BULLETIN # 357

DATE: MARCH, 2001

1610-1, 1630-1 ½" Compact Hole-Shooter Drill, 1670-1, 1675-1 ½" Hole-Hawg Drill

## SUBJECT: - PRODUCT SAFETY RECALL -

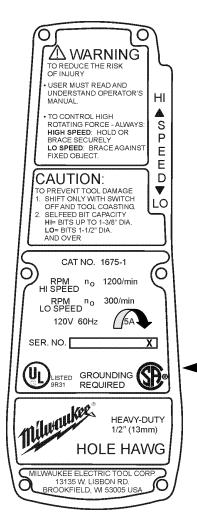
Stamp or etch an  $\underline{'X'}$  next to the ending digit of the serial number on the tool's peplate after the replacement of a recalled 23-66-1020 Switch.

The 'X' will show that the drill has been repaired.

Stamp or etch an 'X' next to the ending digit of the serial number

## SAFETY RECALL

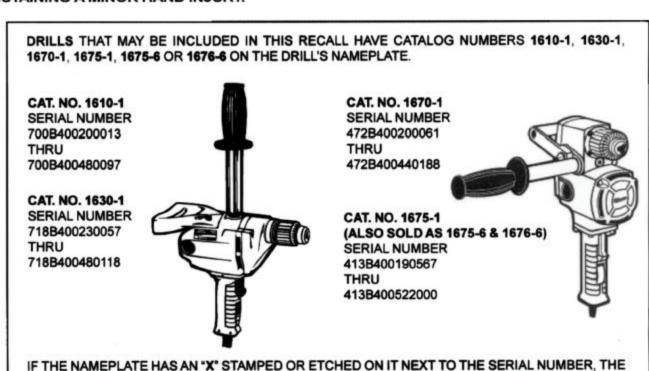
MILWAUKEE ELECTRIC TOOL CORPORATION IN COOPERATION WITH THE U.S. CONSUMER PRODUCT SAFETY COMMISSION (CPSC), ANNOUNCES A RECALL OF CERTAIN 1/2" MILWAUKEE ELECTRIC DRILLS. THESE DRILLS MAY CONTAIN A SWITCH THAT STICKS IN THE "ON" POSITION WHICH COULD RESULT IN OPERATOR INJURY. THERE HAS BEEN ONE REPORT OF A CONSUMER SUSTAINING A MINOR HAND INJURY.

IF YOU HAVE ONE OF THESE DRILLS, STOP USING IT IMMEDIATELY AND RETURN THE DRILL TO THE NEAREST MILWAUKEE FACTORY SERVICE CENTER OR MILWAUKEE AUTHORIZED POWER TOOL SERVICE STATION FOR REPAIR AT NO CHARGE, FOR ASSISTANCE IN LOCATING YOUR NEAREST FACILITY CALL MILWAUKEE TOLL FREE AT:
